Modifications required to fit RAC016 Dynalite in place of original Bosch Dynamo

Original upstand, part number 539.01.145

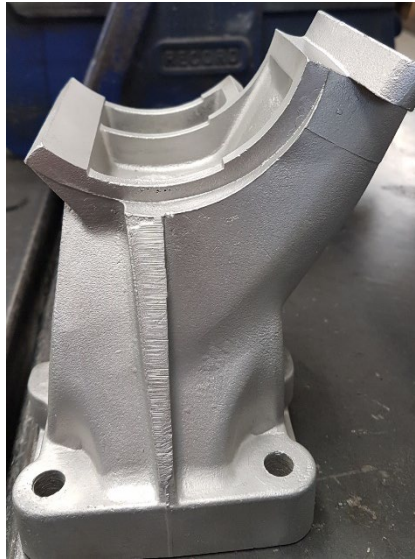
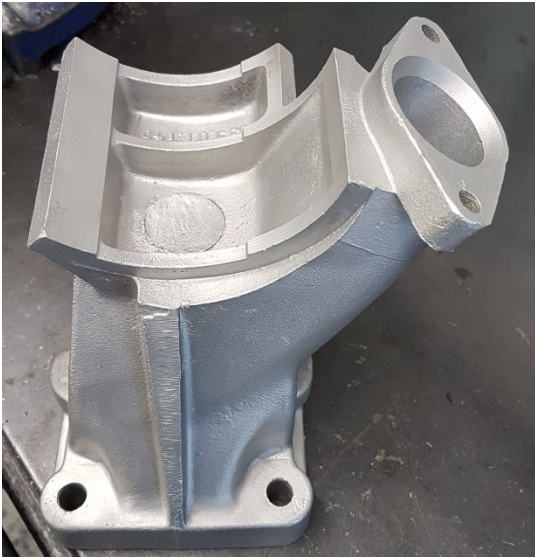
This is the standard bracket which can be machined out to take the new alternator by measuring up the centre line 142mm then machining a 100mm diameter.

Modified upstand

Alternatively we can supply a ready to fit bracket that we have already machined
